BSR/ASHRAE Addendum 55r-201x, Thermal Environmental Conditions for Human Occupancy (addenda to ANSI/ASHRAE Standard 55-2010)

BSR/ASHRAE/IES Addendum cv to Standard 90.1-2010, Energy Standard for Buildings Except Low-Rise Residential Buildings (addenda to ANSI/ASHRAE/IESNA Standard 90.1-2010)

BSR/ASHRAE/USGBC/IES Addendum ad to Standard 189.1-2013, Standard for the Design of High-Performance Green Buildings Except Low-Rise Residential Buildings (addenda to ANSI/ASHRAE/USGBC/IES 189.1-2011)

Figure 3.1 Section and plan views of primary sidelighted area.

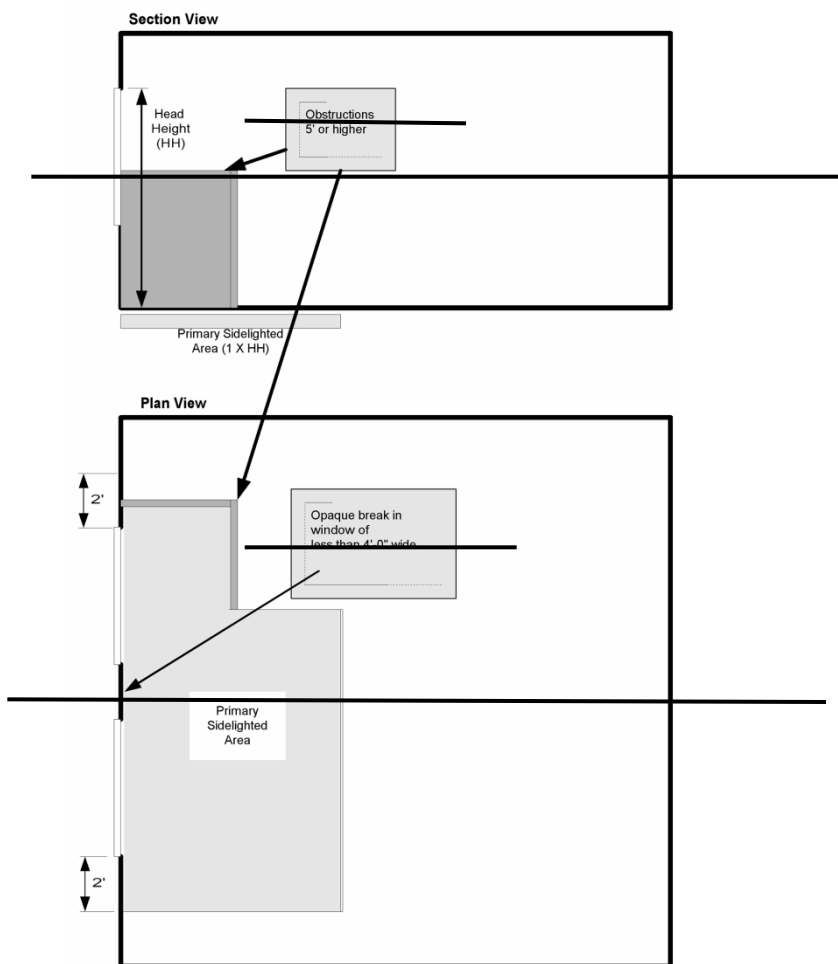
- a. ~~primary sidelighted area (See Figure 3.1):~~ The total ~~primary sidelighted area~~ is the combined ~~primary sidelighted area~~ without double counting overlapping areas. The floor area for each ~~primary sidelighted area~~ is directly adjacent to vertical fenestration in*

Remove the following plan and sectional views:

**Figure 10—Probe for Hot Surfaces Contact Test**

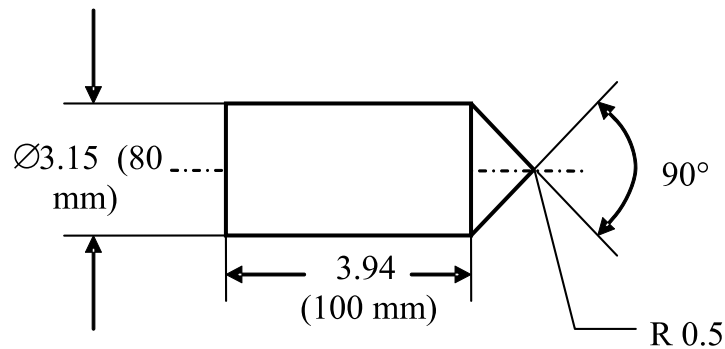
Revisions made to Scope, Probe Test for Power Driven Components, Probe Test for Hot Surfaces, UV Resistance, and the addition of Figure 10.

Allow the power source to cool before using the cone. It is not necessary to test the accessibility of hot parts while they are hot. Apply the test cone shown in Figure 10 in any direction and with a maximum force of 10 N +0/-1 N (2.25 lbf +0/-0.23 lbf). When moving the cone, determine whether there is any contact between the hot surface area or areas and the cone's tip or the conical surface.
